/ S4.55- Phase 2 - Drop off Diagram

Materiality

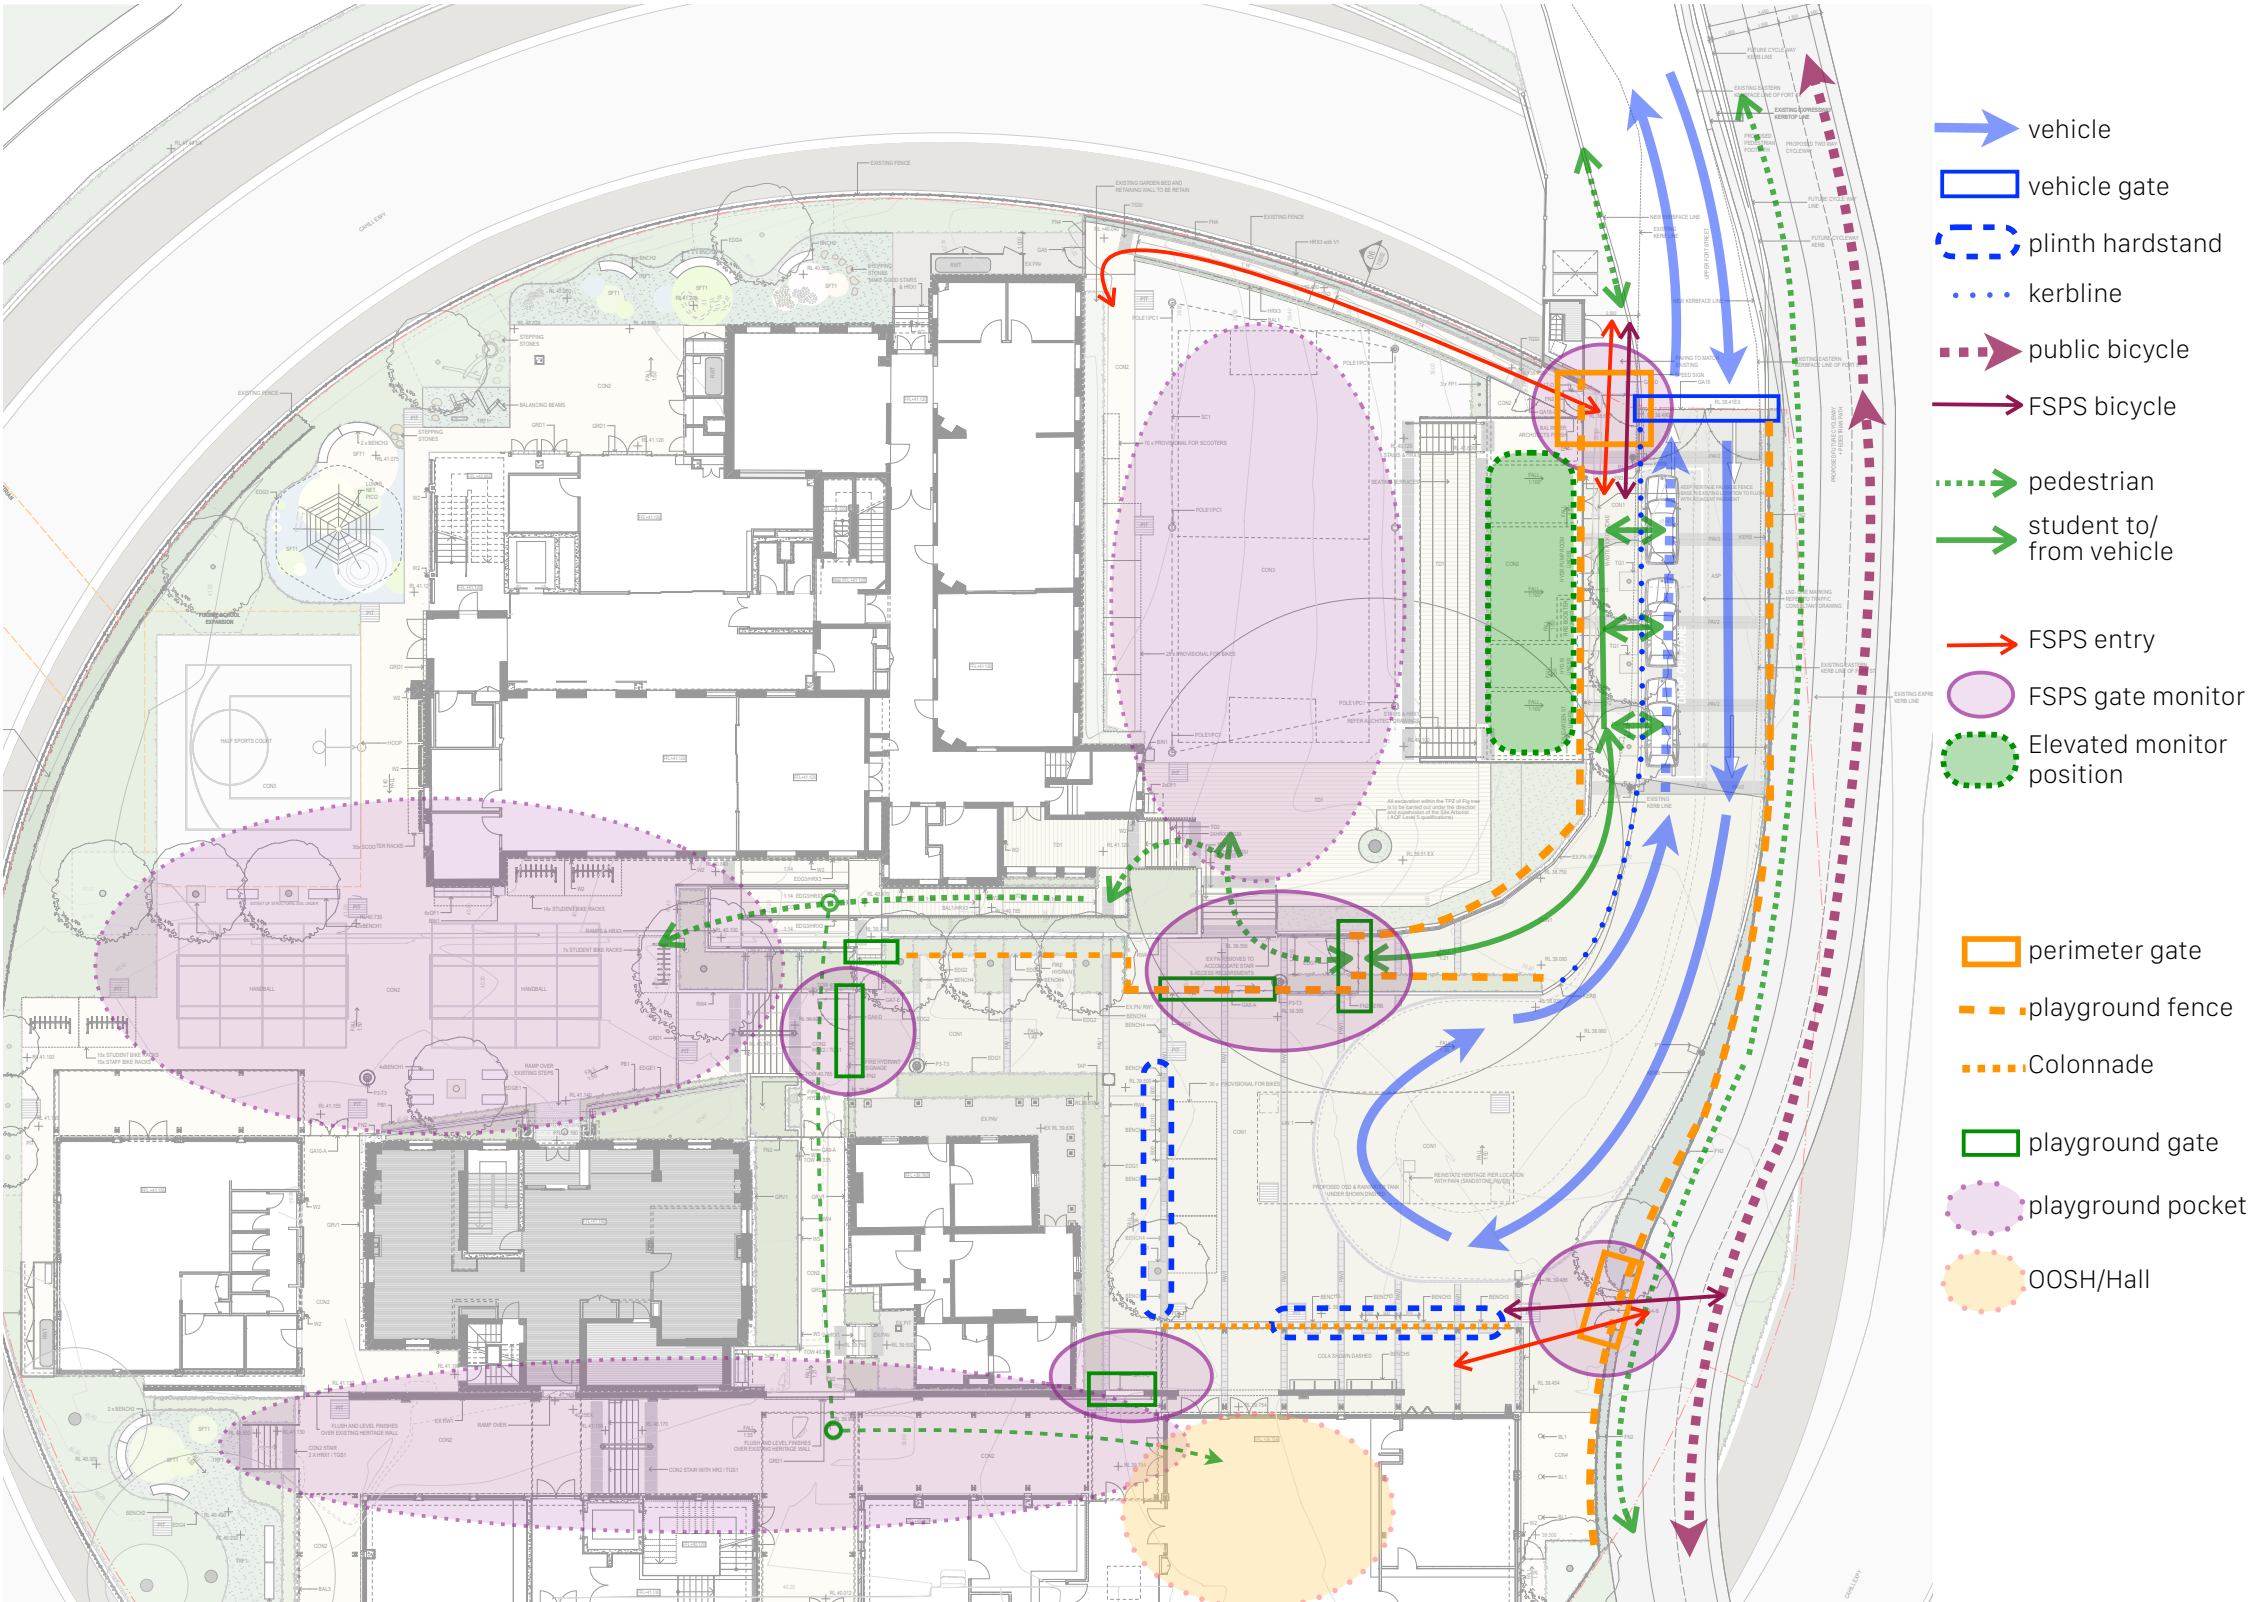
- roadway geometry adjustments in Phase 1 facilitate relocation of vehicle DO/PU pause zones to the space immediately in front of the services amphitheatre building in the north east corner. This further optimises the segregation of DO/PU activities beyond the eastern courtyard. Sight lines in and along linear alignment of stationery vehicles is aided by this alignment;

- the north-eastern entry gate added in Phase 1 will be adjusted slightly to be re-oriented to suit the Phase 2 vehicle gate;
- the sliding vehicle gate will be removed in Phase 2 as the new swing gate will be in place as was the case for the approved design. Other elements such as flush and raised kerbs installed as part of Phase 1 will be retained as they contribute to vehicle and pedestrian movement elements;

- the Phase 1 pedestrian crossing will be removed. At that stage the north-south public and school pedestrian movements will shift outside the site boundary to the future shared footpath envisaged as part of the Harbour Bridge cycleway upgrade works, outside the scope of this project;

- other measures within and around the eastern courtyard established as part of Phase 1 will be retained.

Facade Type 01 and 02

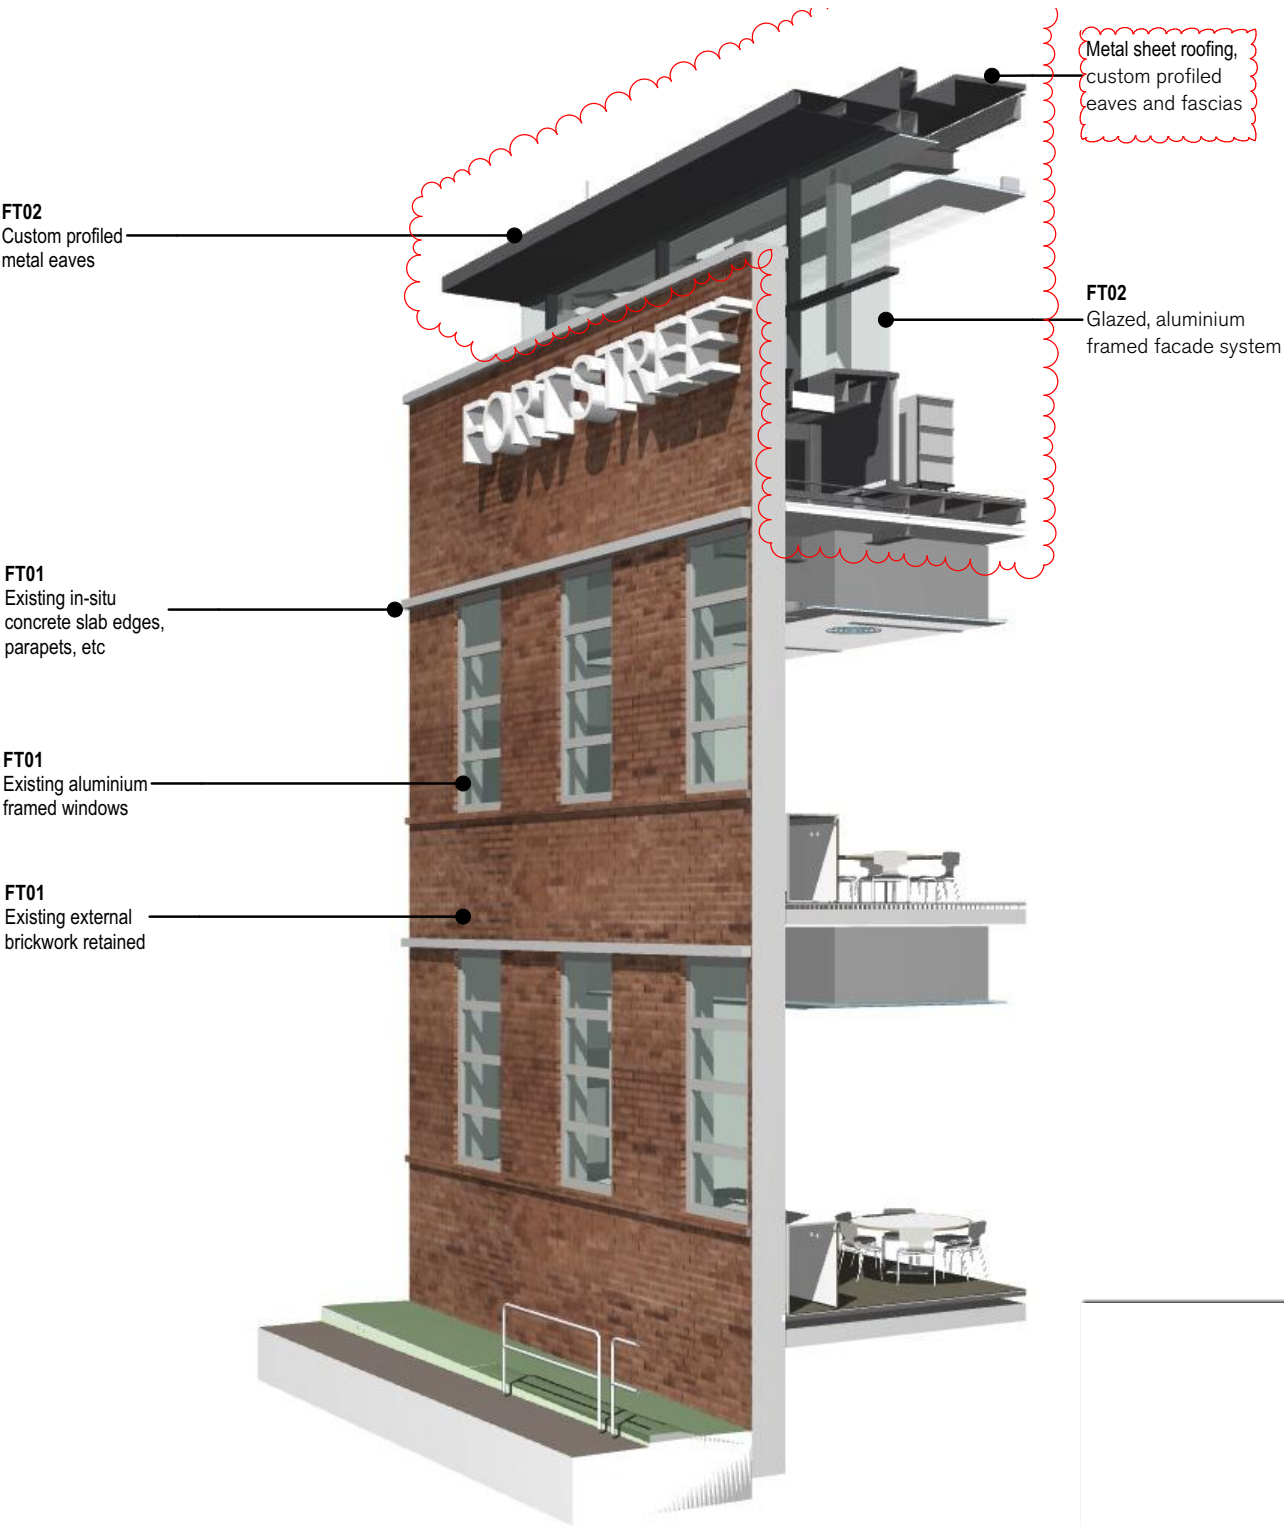
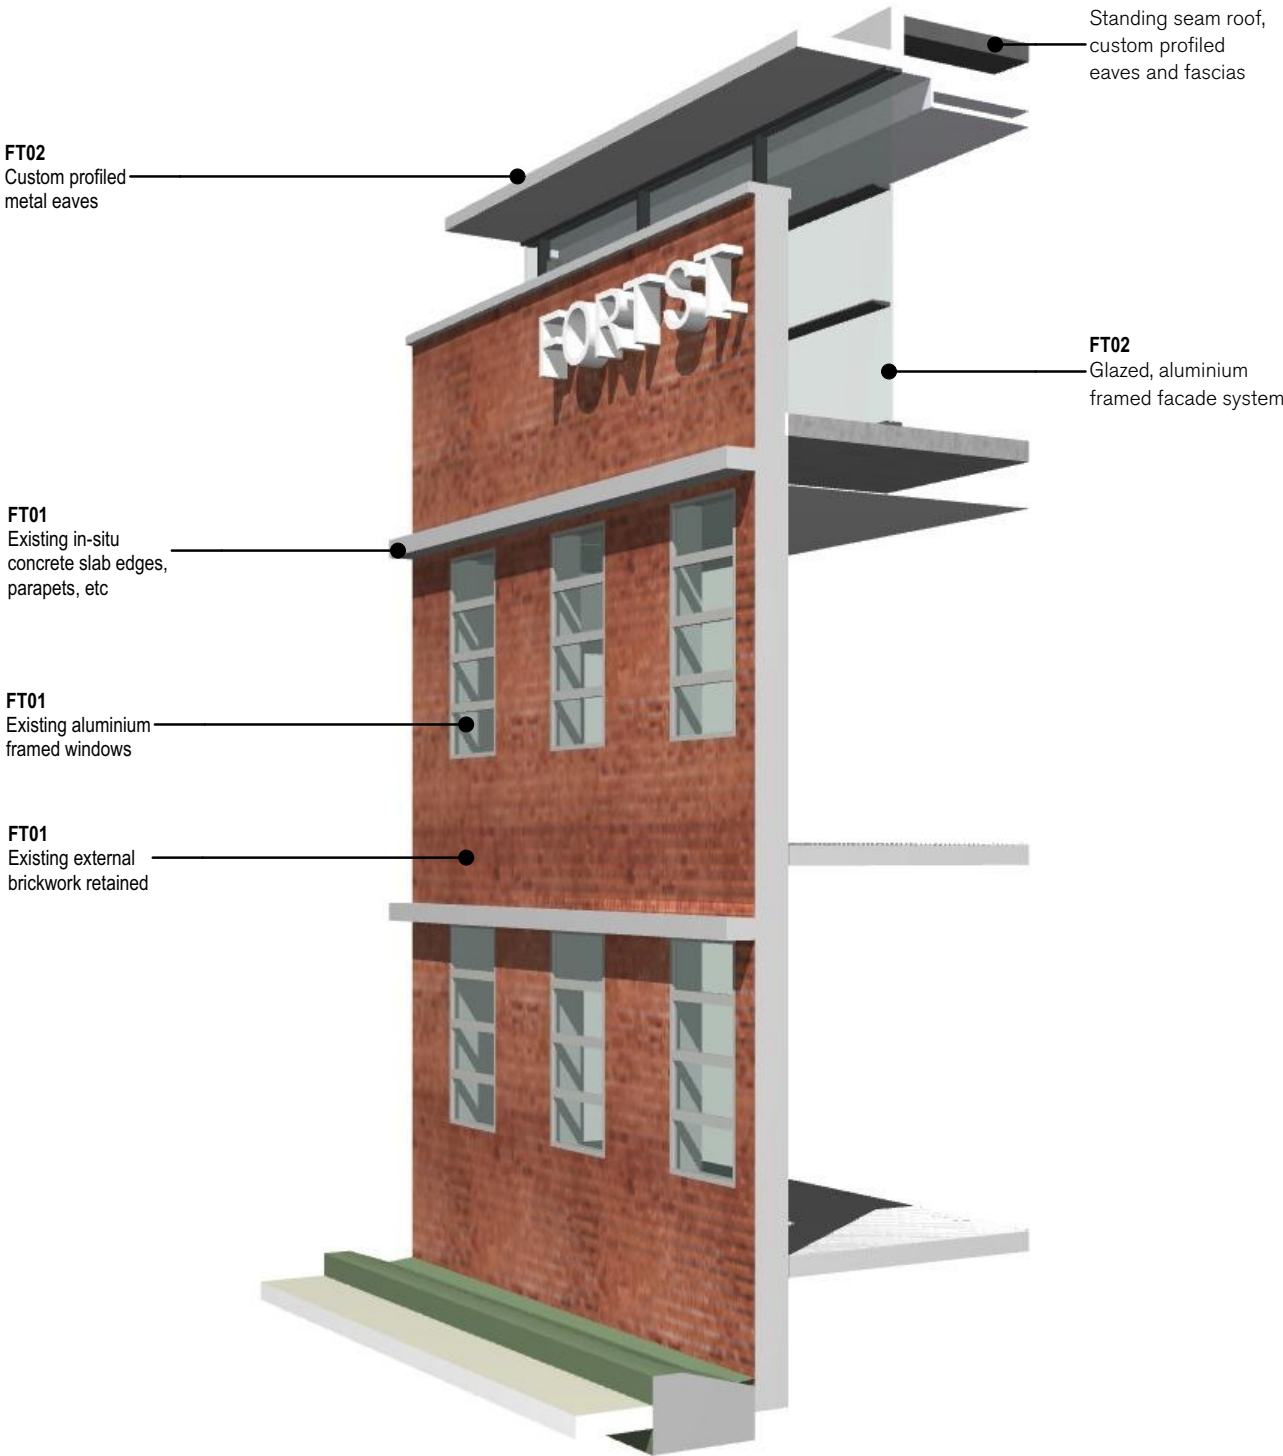
Facade Type	Description	Section 4.55 Modifications
General	All glazed facades	— General amendments to placements of solid to glazed, to suit plan changes
FT01	Existing Building A FSPS Facade	— Nil
FT02	Building D - L2 Facade	— Ratio of solid and glazed panels revised. — Drainage system detail updated
FT03	Building D North-West Glazed Mesh Facade	— Revised Spandrel heights and extents — Revised steel structure for L2 and Roof
FT04	Building D Brick Facade	— Louvred ventilating facade to western elevation/ Stair — Amendments to articulations
FT05	Existing Building C Facade	— Nil
FT06	Building C Extension Facade	— Building C Extension removed
FT07	Building F and G Facade	— Louvred facade to western elevation/ Stair — Amendments to articulations
FT08	Existing MET Brick Facade	— Nil
FT09	Proposed MET Lift Facade	— Previously proposed MET lift removed
FT10	Building J and H Facade	— Revised Materiality to Exposed Brick — Detailing of Aluminium Panels revised — Louvred facade to southern elevation/ Stair within J
